# Access Compliance Report

### (Curb Ramps)

Intersection ID: N/A	Main Street: COPPER_WY	Cross Street: N/A	Location: NE
ADA ID: 88E29C891094	Ramp Type: PerpDiag	Initial Pass/Fail: Fail	Overall Compliance: No
		Severity Score: 10

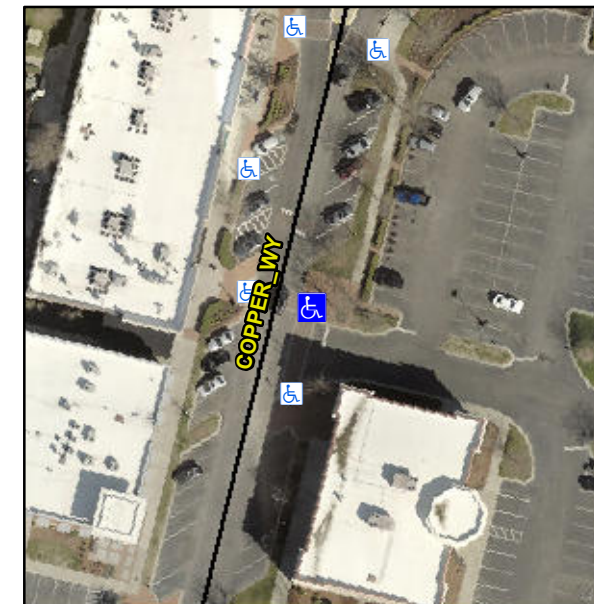
**Not Found, R304.5.1, R304.5.3**

Compliance	Description	Data	Compliance	Description	Data
N/A	Ramp Length (in)	71.0	Yes	Ramp Slope (%)	7.8
No	Ramp Width (in)	37.0	No	Ramp XSlope (%)	3.3
N/A	Flare Type LT	N/A	N/A	Flare Type RT	N/A
N/A	Flare Slope LT (%)	N/A	N/A	Flare Slope RT (%)	N/A
N/A	Flare Traversable LT?	N/A	N/A	Flare Traversable RT?	N/A
N/A	Landing Length (in)	N/A	N/A	DWS Provided?	N/A
N/A	Landing Width (in)	N/A	N/A	DWS Contrast?	N/A
N/A	Landing Slope (%)	N/A	N/A	DWS Length (in)	N/A
N/A	Landing X Slope (%)	N/A	N/A	DWS Full Width?	N/A
N/A	Landing Curb? (Y/N)	N/A	N/A	DWS Offset (in)	N/A
N/A	Shared Landing?	N/A			
N/A	Gutter Ponding?	N/A	N/A	Gutter Slope (%)	N/A
N/A	Gutter Lip Ht (in)	N/A	N/A	Gutter X Slope (%)	N/A
N/A	Painted X Walk1?	Yes	N/A	Painted X Walk2?	Yes
	X Walk 1 Direction	To NW		X Walk 2 Direction	To SW
N/A	X Walk 1 Width (in)	101.0	N/A	X Walk 2 Width (in)	101.0
	X Walk 1 Slope (%)	0.9		X Walk 2 Slope (%)	1.0
	X Walk 1 X Slope (%)	1.1		X Walk 2 X Slope (%)	1.8

**Remove & Replace Curb Ramp With Two New Directional Ramps or Equivalent.**
